SUBJECT: Forwards potential finding repts processed & classified by
 GA CO as invalid, observation or out of scope.

Subject: Docket Nos. 50-361 and 50-362
San Onofre Nuclear Generating Station
Units 2 and 3

Enclosed are sixty-three (63) copies of the Potential Finding Reports (PFR) which have been processed and classified by General Atomic as follows:

Sheet 61 of 91
M1204-043 2B
DWG. NO. 1204-059-1

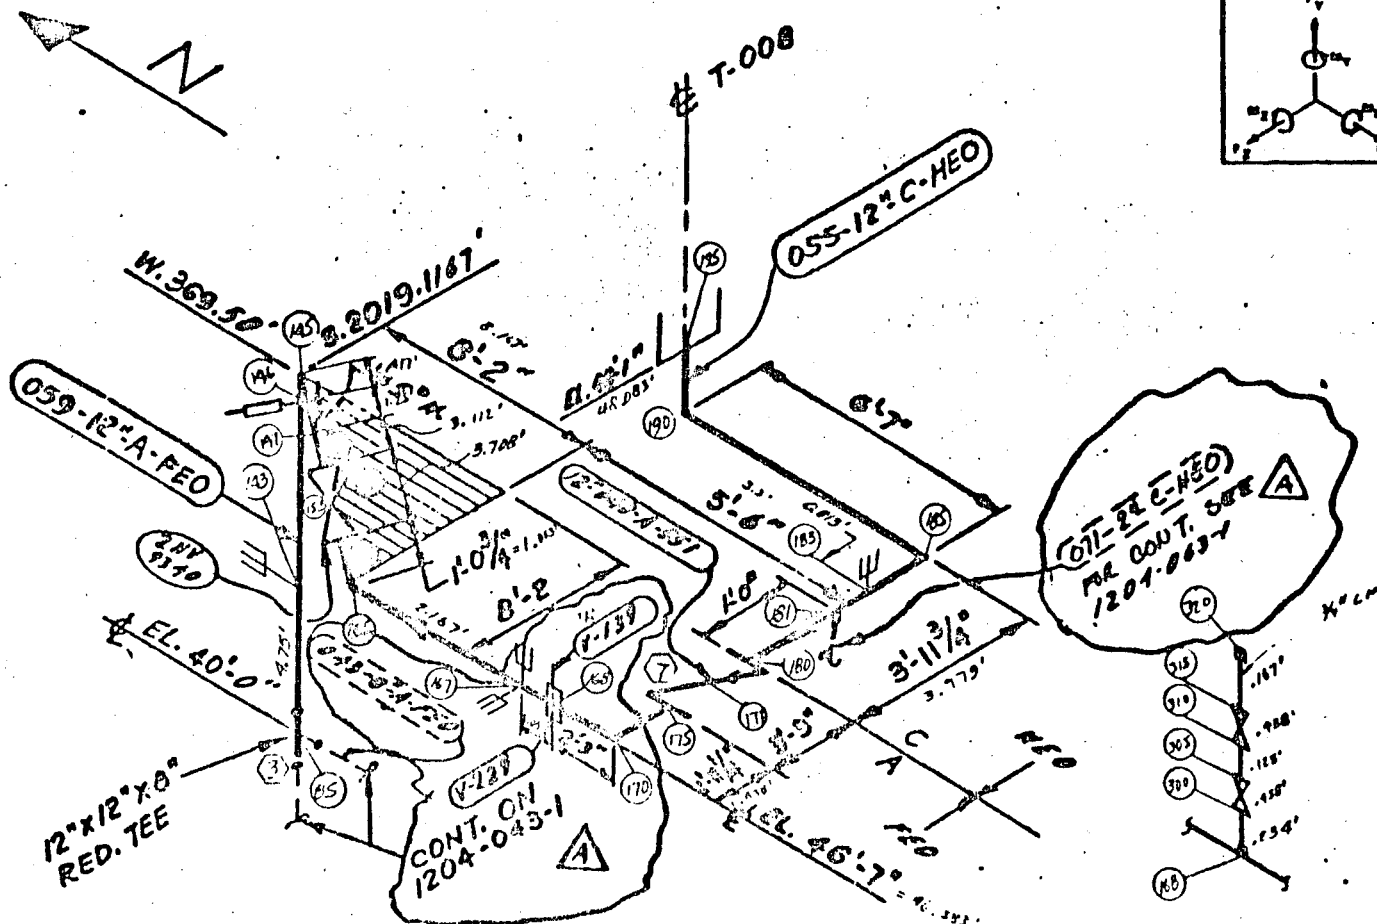
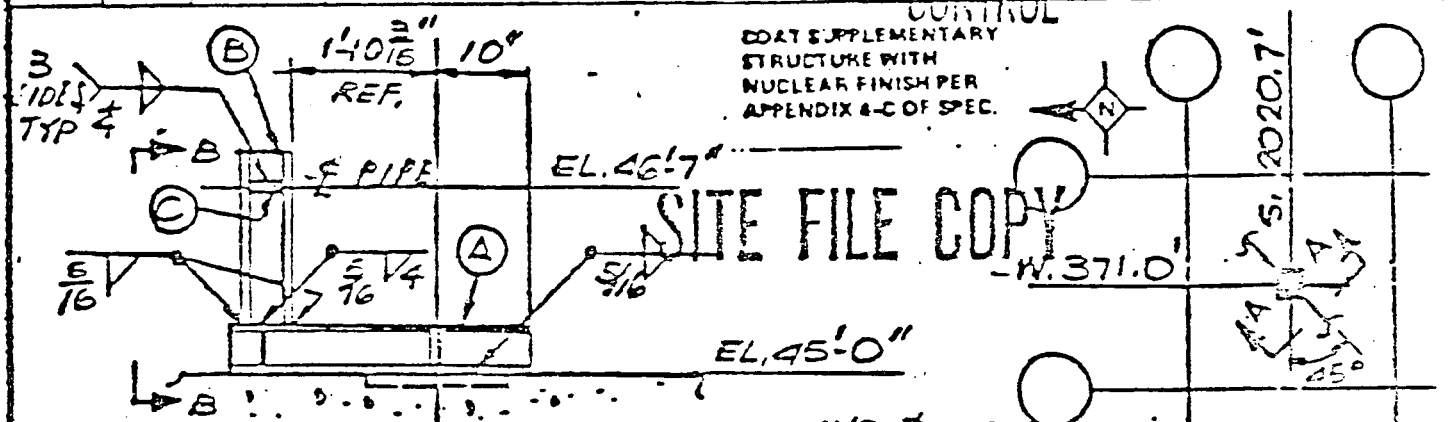
DESCRIPTION OF POTENTIAL FINDING: ISO Drg. No. 1204-059-1 and sheet 63 of PSG-78 call for a spring support at node 147. Computer run Q22L27 calls for a rigid support with spring constant of 1050 lbs/in. (spring). Where as Drg. No. S2-S1-059-H-009 calls for Mech. Snubber at Node 147. This is inconsistent.

The node point (147) callout on dwg. no. S2-SI-059-H-009 is incorrect. It should read 146. The location of the snubber, as shown on the support drawing, agrees with the location shown on the isometric and used in the computer analysis. Therefore, the analysis is correct.

☒ AGREE PFR IS VALID - Minor inconsistency; correction would not change design.
☐ DISAGREE

Prepared by:	Reviewed by:	Approved by:
JWW KMS	JCH ZJB	WMS SJO
JOB NO. 1334703	SKETCH NO. S022SK-S-553	REV. A

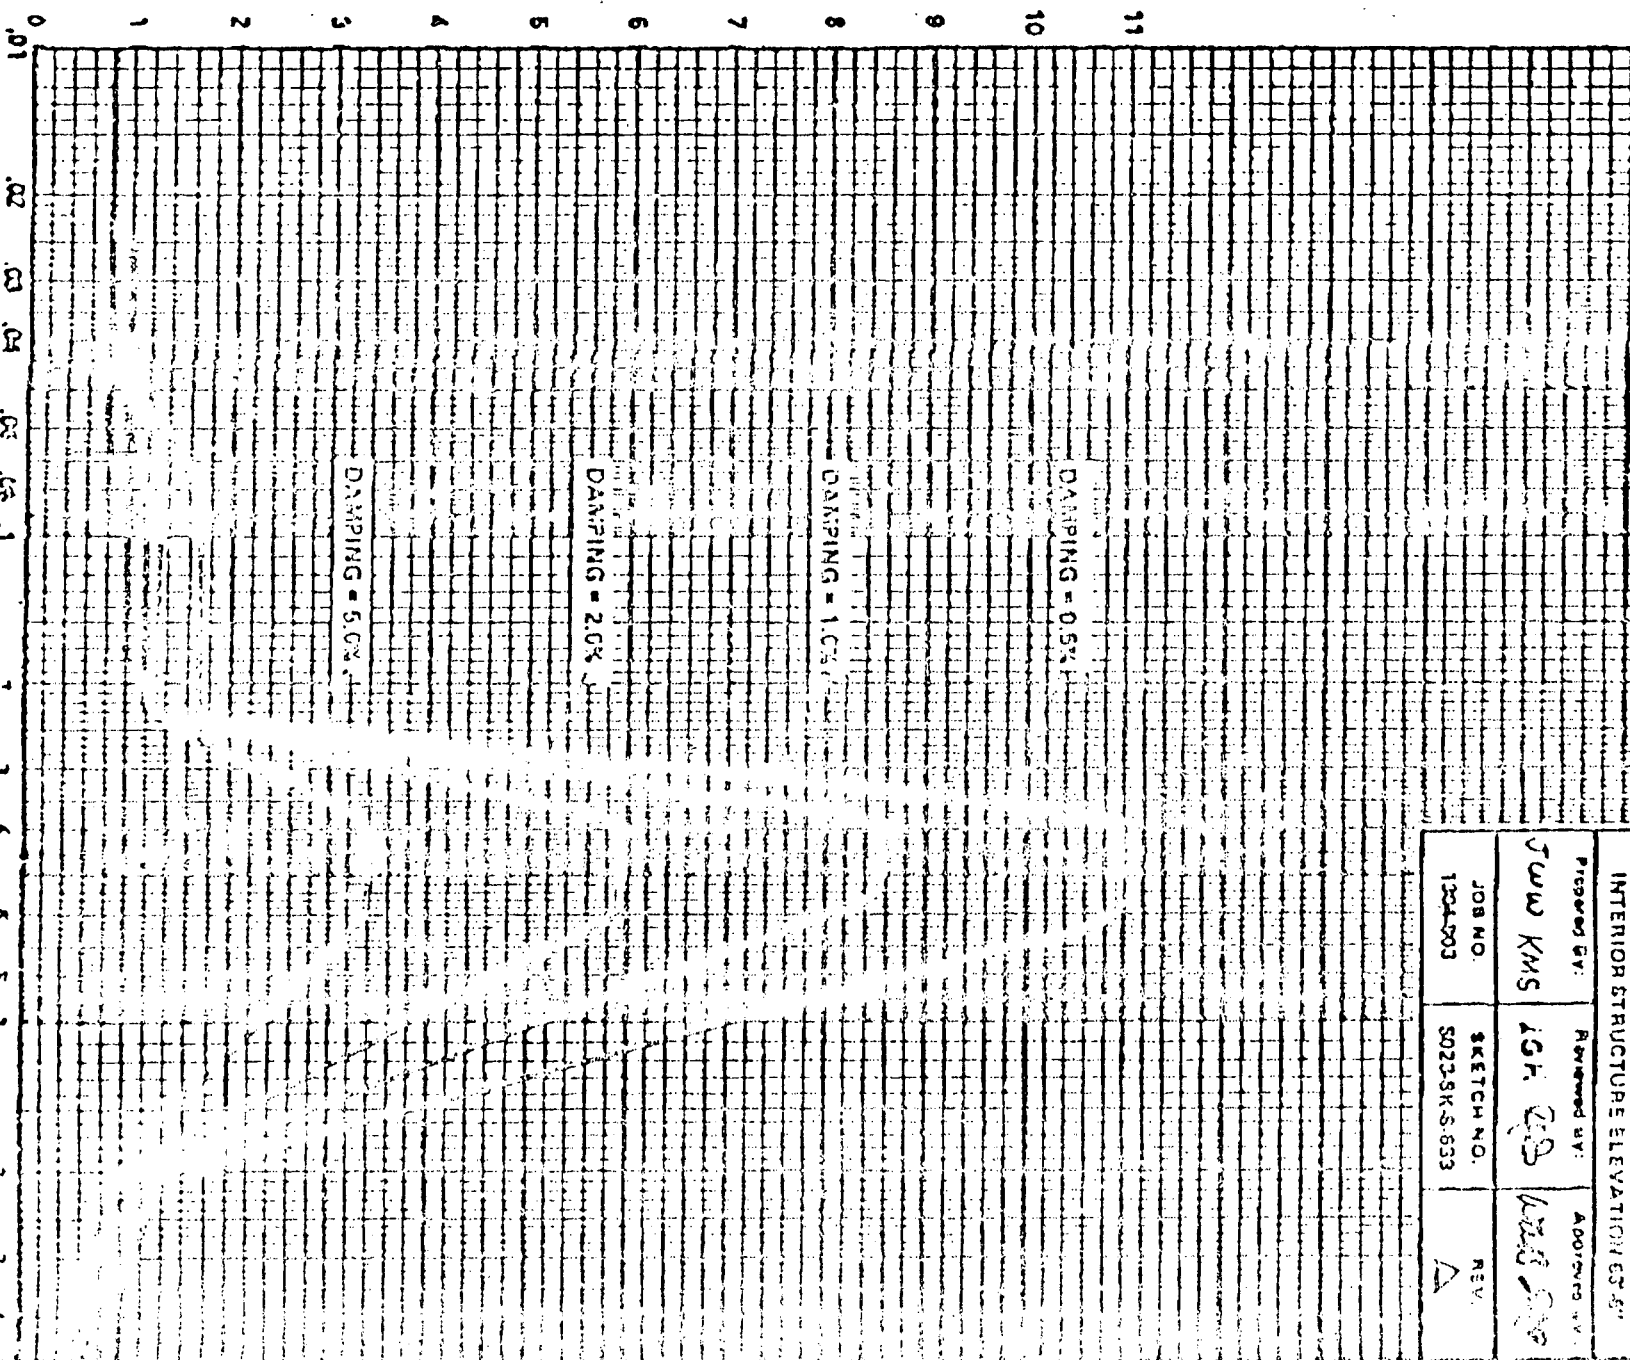
ALG.
Therefore, No in-structure response spectra at the instrument mounting location are given. In addition, the basis for the choice of design seismic acceleration g-levels used in calculation sheets 19, 21, and 23 is not stated in the calculation file. These three sheets are attached herewith for additional information.

The attached instructure response spectra serves as basis of design for the instrument installation. Generally, 5% damping characteristics and DBE serves as basis of the design of the instrument installation. While the engineer has not specifically referred to the response spectra in the calculations, the accelerations are equal or greater than shown in the response spectra.

Level transmitter (2LT-0312) is located in the containment at elevation 63'-6". The review of seismic response spectra curves for the area indicates that seismic acceleration at 15 Hz does not exceed "2.0 g" horizontally and "1.5 g" vertically (minimum of the assumed values in Snts. 19, 21, 23). Actual "g" levels at this elevation for frequency of 15 Hz are "1.2 g" horizontally and "0.8 g" vertically (RSS curves S023-SK-S-633 and S023-SK-S-634). For this floor stand, a frequency of 15 Hz was assumed in the calculation. This frequency was verified by calculations. The calculated frequency is more than minimum frequency of 10 Hz stated in FSAR paragraph 3.10.3.2. The assumptions made in calculations are conservative.

The attached in-structure response spectra supplied by BPC serve as the basis for the instrument field mounting design. In order to verify the design acceleration values used in the calculation file as appropriate and conservative, the reviewer conducts the following check. First, the natural frequency of the floor mounting stand was calculated. Then from the in-structure response spectra (Figures S023-SK-S-633 and S023-SK-S-634) the actual acceleration levels at this frequency were found (1.2g horizontal and 0.8g vertical at the design frequency of 15 Hz). These actual values are lower when compared with the minimum design values of 2.0g horizontal and 1.5g vertical. Therefore, the reviewer concludes that the design acceleration values used in the calculation file are appropriate and conservative. This PFR then becomes invalid.

SHEET 43 OF 77

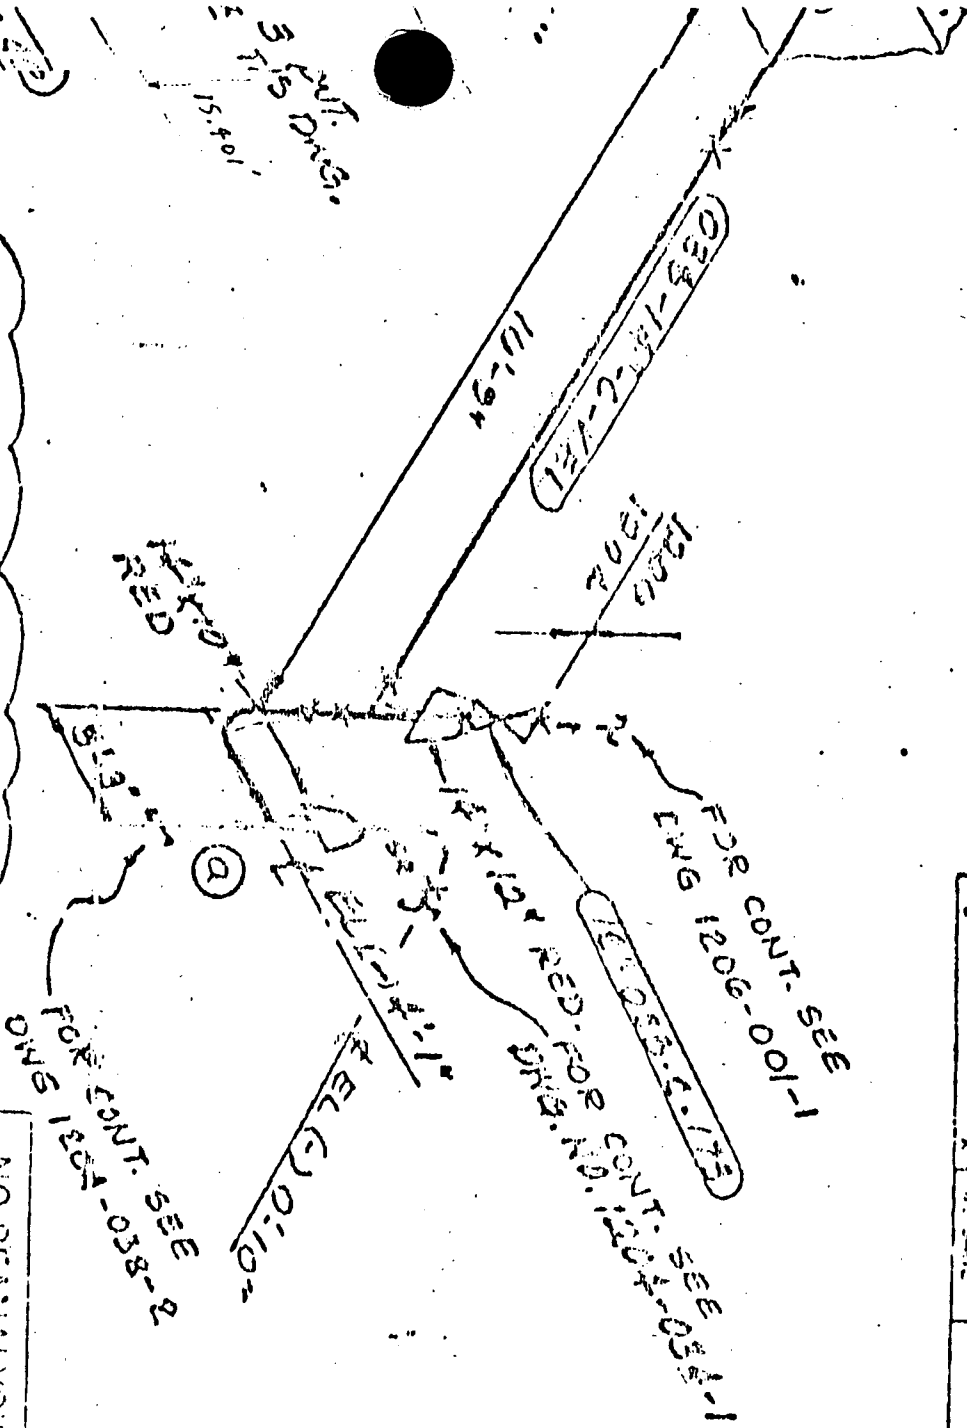
ISO sketch drawing No. 1204-038-1 shows a major configurational difference between Unit No. 2 and Unit No. 3 piping arrangements. The stress report only documents the loads developed in the Unit No. 2 configuration. There is no documented justification for the Unit No. 3 configuration in PSG-57. *1/26/82*

Documentation for Unit 3 configuration is being finalized in another stress analysis package (PSG-546) which will include ongoing design modifications.

I am satisfied that the documentation for Unit 3 configuration is being finalized in another stress analysis package (PSG-546) and, therefore, agree with BPC response with this PFR (2408-PFR-0054). I agree with this PFR is invalid.

SUBJECT: NOZZLE CONNECTION LOADING SHEET NO. 82 OF 87

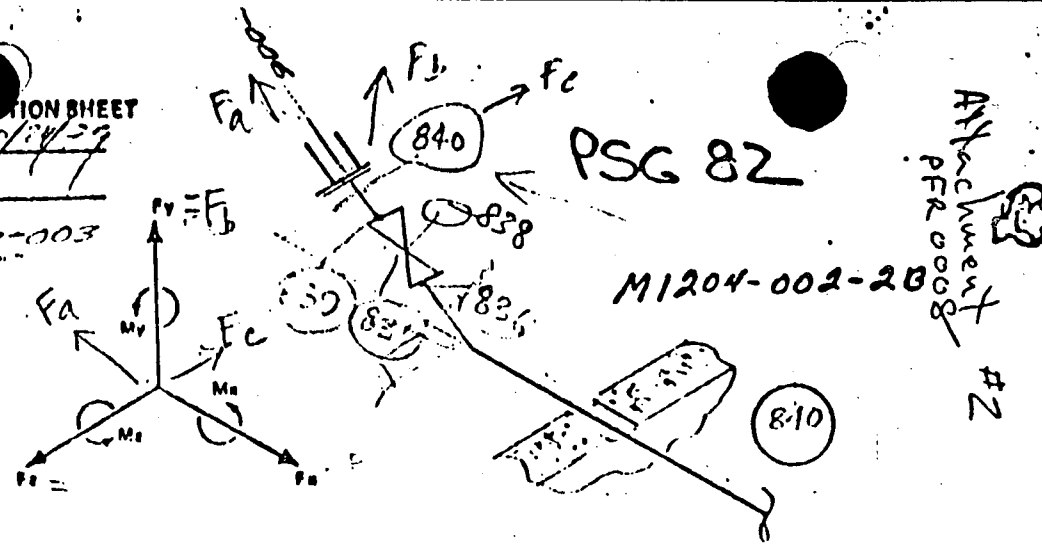
BASIC REQUIREMENT: The scope of Ref. 1 includes the design of nozzles on S.I. Tanks for both Units 2 and 3. The Ref. 2 letter states that the attached nozzle load tables are for safety injection tanks in Unit 2. The nozzle load table for Tank 007 is marked applicable to Unit 2 while load tables for Tanks 008, 009, 010 are marked as applicable to both Unit 2 and 3. The validity of nozzle loads used by C-E for Tank 007 in Unit 3 are in question.

Loads in Bechtel Letter BC-1617 were transmitted when Bechtel realized they had exceed the C-E allowable nozzle loads as given in C-E Spec. 1370-PE-603. C-E then selected the maximum loads from this letter (from Tanks T-007 and T-009) to determine if these loads were acceptable, in order to provide a bounding solution. Any loads less than or equal to the loads provided by Bechtel whether they are for Unit 2 or Unit 3 would be acceptable. In the event that higher loads are calculated for Unit 3, it is anticipated that Bechtel will once again notify C-E and ask for our concurrence to use these higher loads.

It is our understanding that the Bechtel analysis for Unit 3 is not yet complete. Note that C-E Letter S-CE-6756 dated July 31, 1981 to Bechtel relative to these loads does not reference a specific plant or tank, but refers to any tank on either Unit 2 or 3.

Therefore we do not believe that the question of the nozzle loads used by C-E to be a valid concern.

SIGNATURE S. BRENZ DATE 10/3/77CHECKED R. Kane DATE 12/1/77 2/3/82 JSEPROJECT SAVES UNITS 2 & 3JOB NO. 1504-779PROJECT 150' & CONTAINMENT STRUCTURE MODEL SHEET 6-E OF 10-E SHEETS

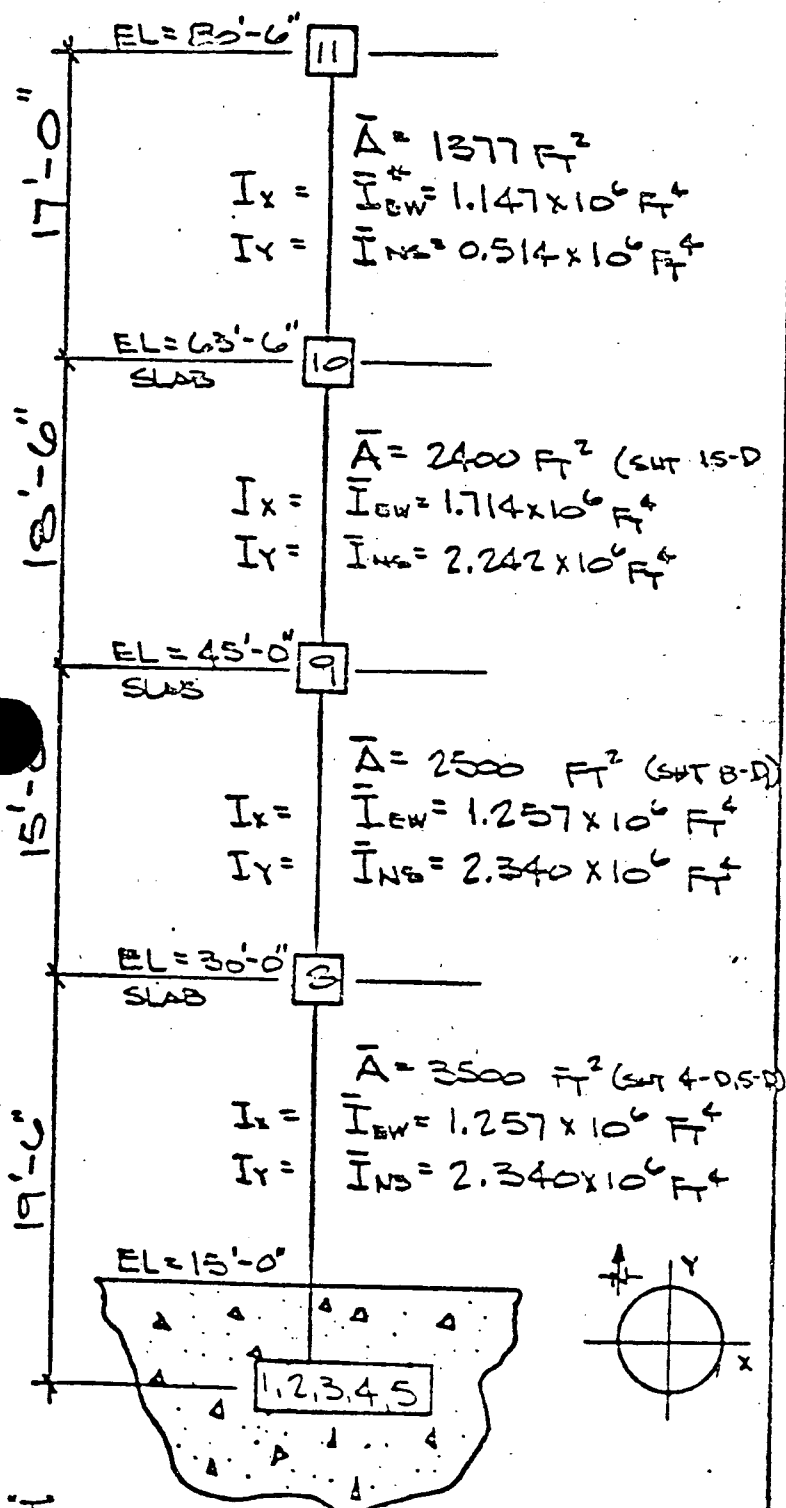
Note that the reviewer attempted to justify these direction-dependent mass values from the master-slave nodal relationship but still could not verify these values. Nor could the reviewer duplicate the same ratios of mass values by considering the fact that vertical input level is 2/3 of the horizontal input level. Theoretically, inertia values do not depend upon directions of translational degree of freedom.

- (a) The total mass along horizontal direction for node 10 = 11002 k, which includes the steam generator mass = 1893 k (refer to attached sheet 6-E).

The steam generator mass along vertical direction was not assigned to node 10, but distributed to nodes 2 and 3 instead. This distribution of mass was used in recognition of the snubber-type supports of the steam generator. Therefore the mass along the vertical direction for node 10, $Y_{(10)} = 2/3(11002-1893) = 6073$ k as stated in the attached sheet 10-E. The $2/3$ factor was introduced to scale down the inertial forcing function on the right hand side of the equation of motion, which in the calculation sheets is defined as the weighing array used to represent the vertical seismic input as $2/3$ of the horizontal input:

The above mass values along the horizontal and the vertical directions are also evident in the attached calculation sheet 6-E, where for node 10:

Along the horizontal direction the mass of the snubbers was subtracted from node 16 and transferred to nodes 26 and 27, as stated in attached sheet 6-F. The total mass along the horizontal direction at the level of nodes 16, 26 and 27 equals 252 k, as indicated in the attached sheet 15-F:
